Report to the Plan Commission

Legistar I.D. #14032
3901 Hanson Road
Certified Survey Map Referral

Requested Action: Consideration of a three-lot Certified Survey Map (CSM) of 37.9 acres of property owned by McAllen Properties Madison, LLC and located at 3901 Hanson Road

PARKS DIV.
EXHIBIT

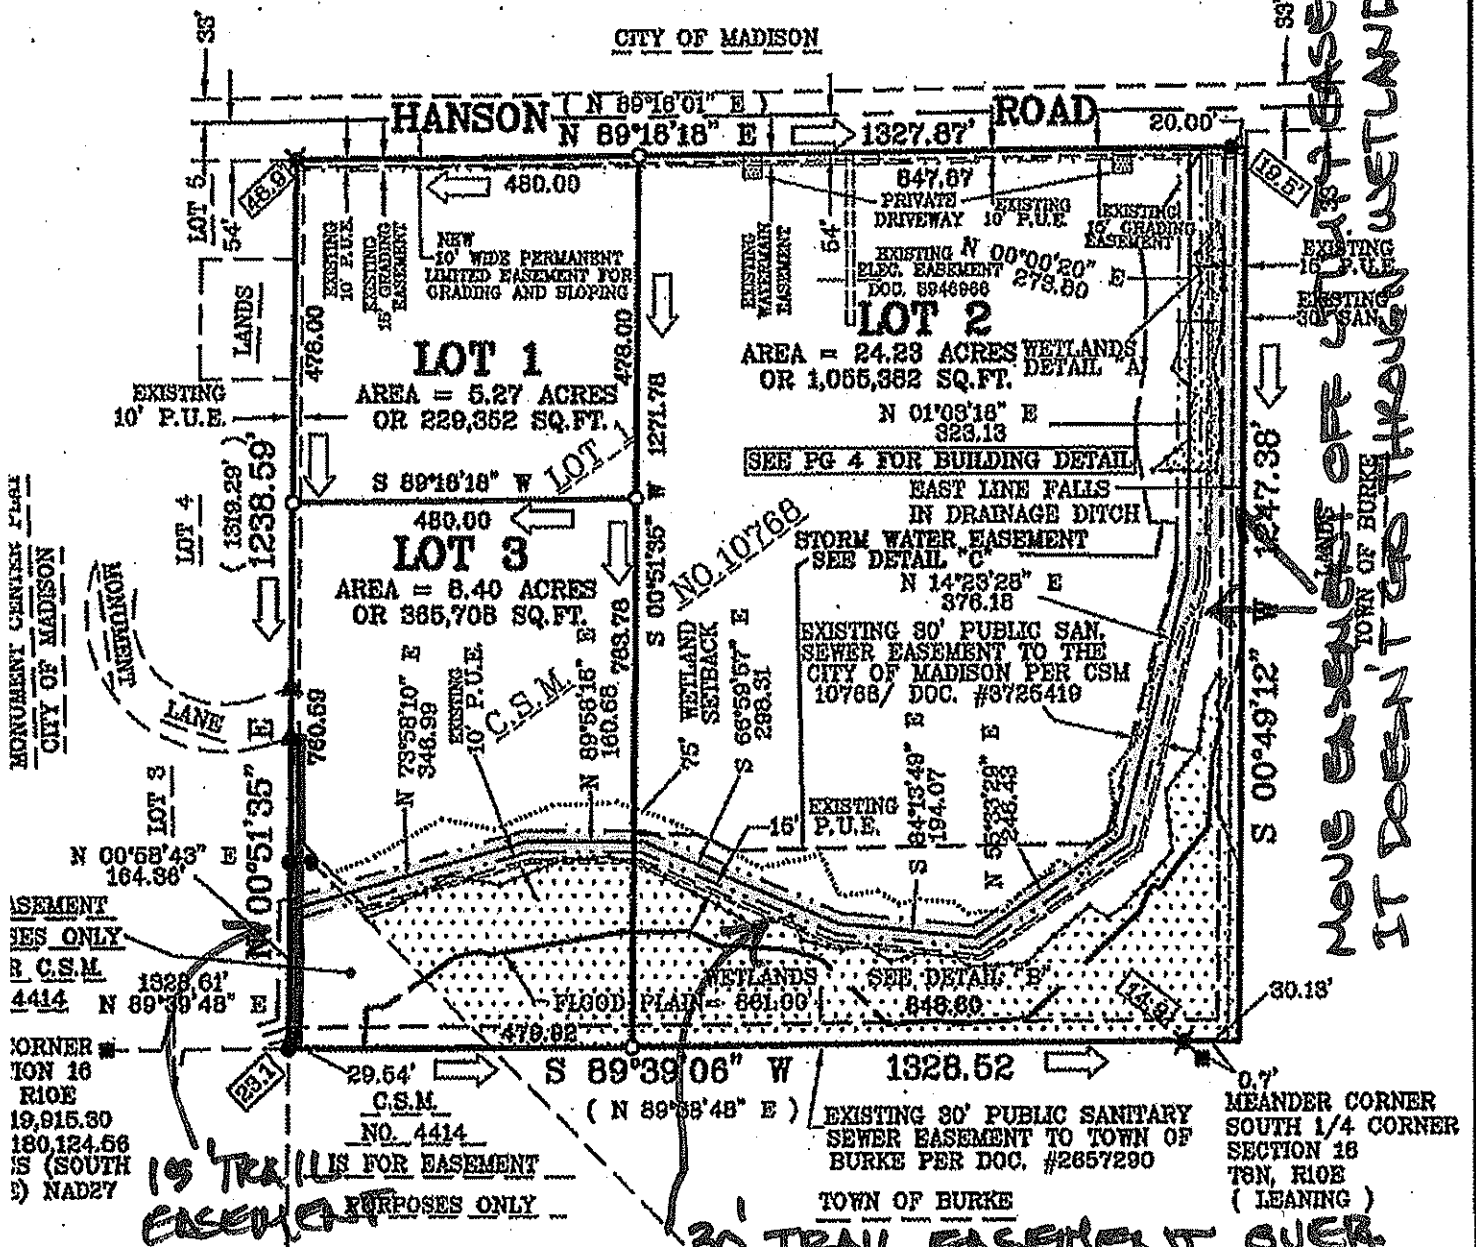
23. The developer will be required to provide a 15-foot wide bike trail easement starting at the southwest corner of the parcel and heading north to Monument Lane, which will result in a total of 30' of easement considering the parcel to the west that already has a 15-foot easement along the west property line.
24. The developer will be required to provide 30-foot bike trail easement over the existing city sanitary sewer and/or other sewer easement that runs adjacent to the wetlands along the south and east property line, heading north to Hanson Road. The bike trail easement should not be on platted wetlands.
25. The developer shall install the gravel base for the bike trail, centering it on the easement along the southern and eastern property lines. The gravel base is to be 12 feet wide and 9 inches deep.

MOVE EASEMENT OFF SURVEY EASEMENT
 IT DOESN'T GO THROUGH WETLANDS

30' TRAIL EASEMENT OVER EXISTING UTILITY EASEMENT
